CONSTRUCTION PLANS
FOR
**PONDEROSA AT
LORSON RANCH FILING NO. 3**
STREET/STORM SEWER AND UTILITY CONSTRUCTION PLANS

COVER SHEET
STREET/STORM SEWER
AND UTILITY PLANS

PUDSP-19-010

TYPICAL CROSSSPAN LAYOUT (ECM SD 2-26)
NO SCALE

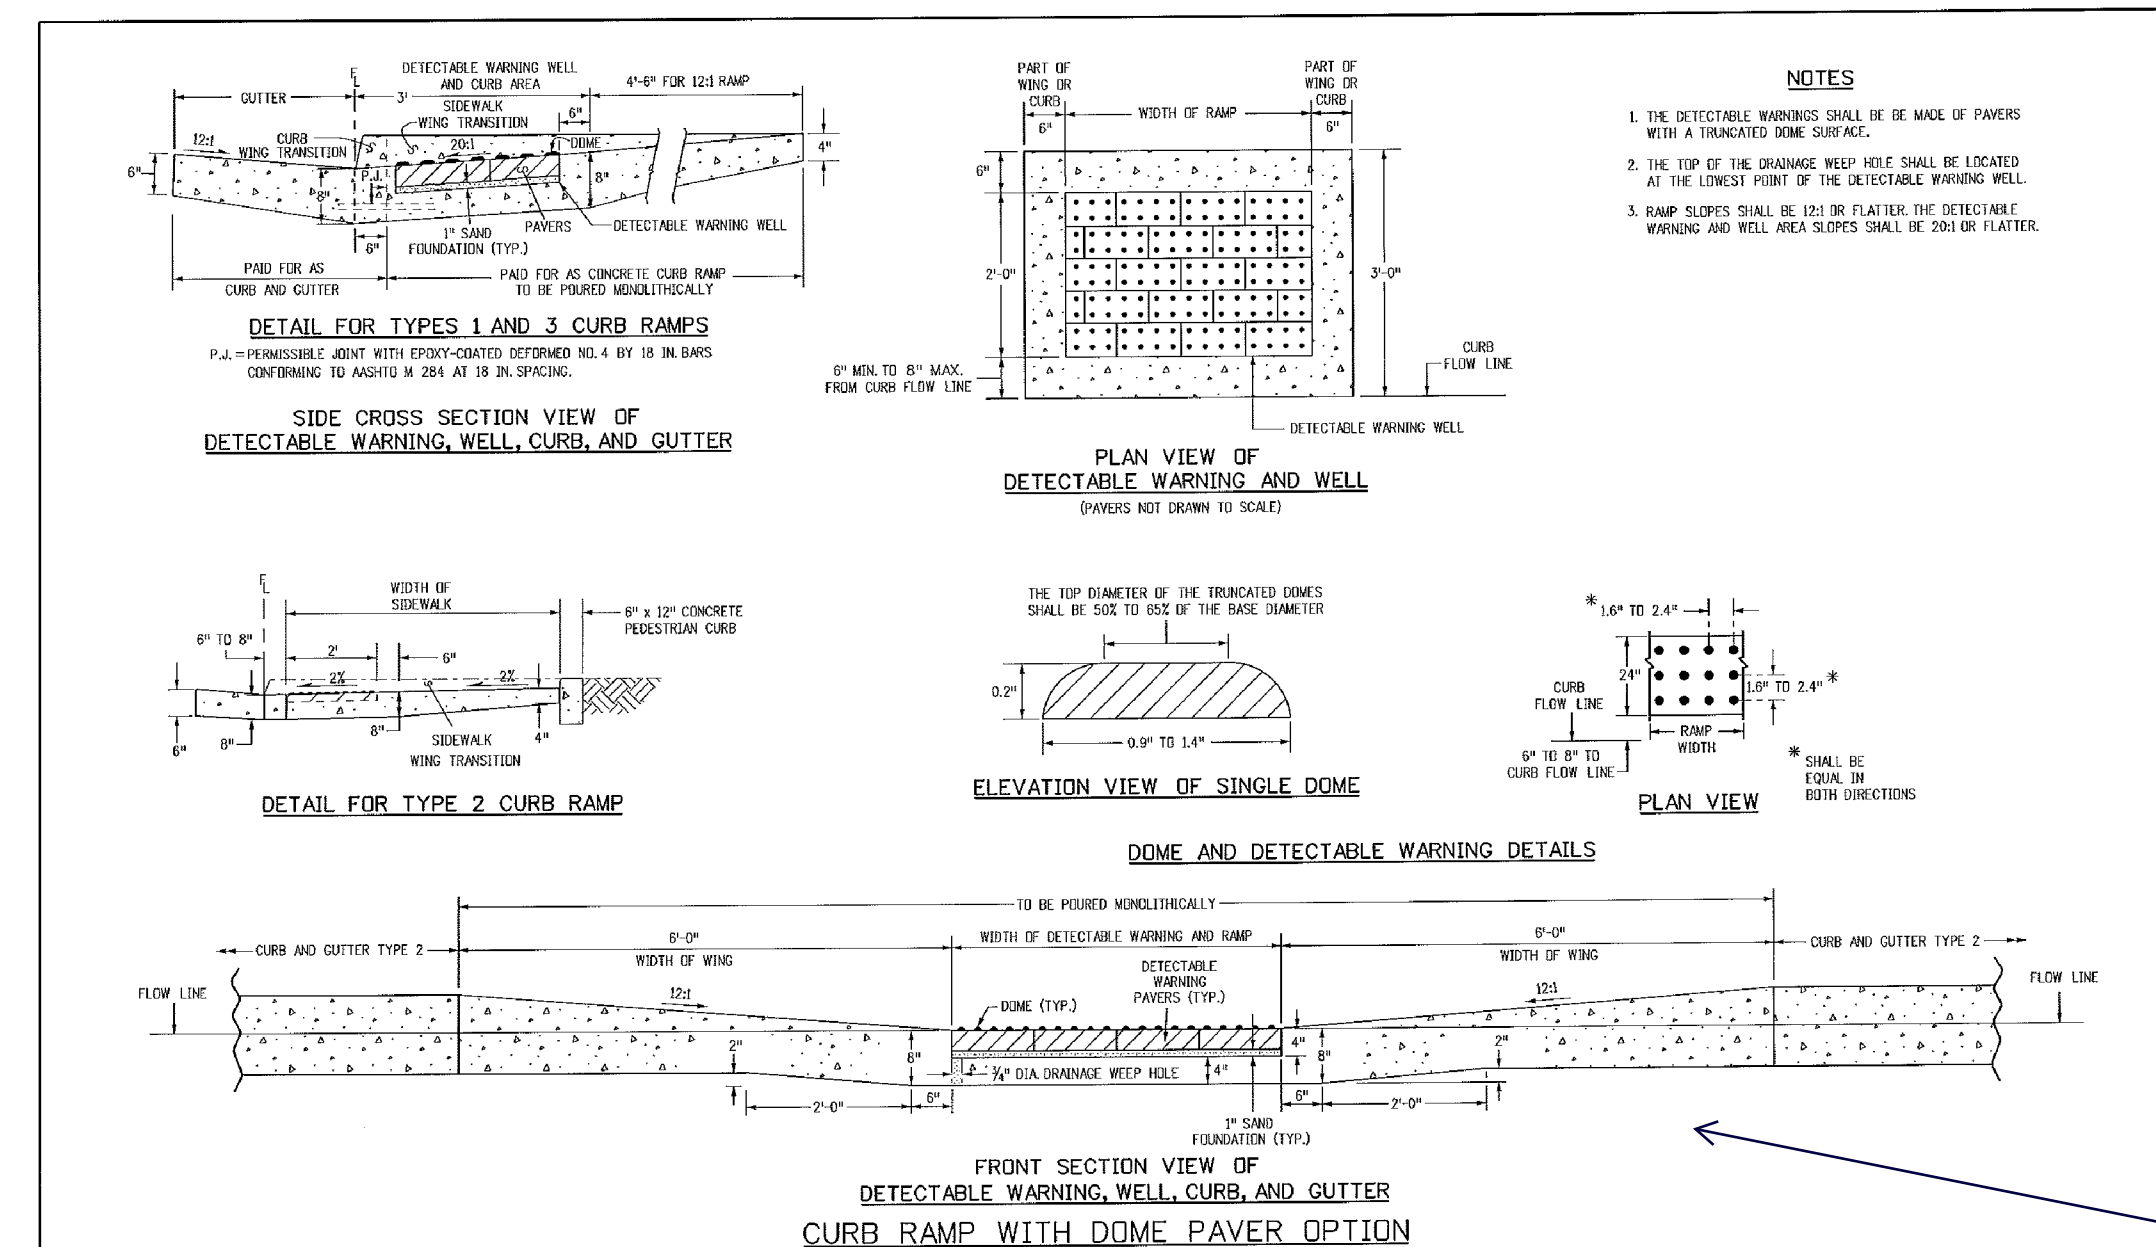
Remove and replace with the latest county detail. New detail calls for cast iron plate. Pavers will not be accepted.
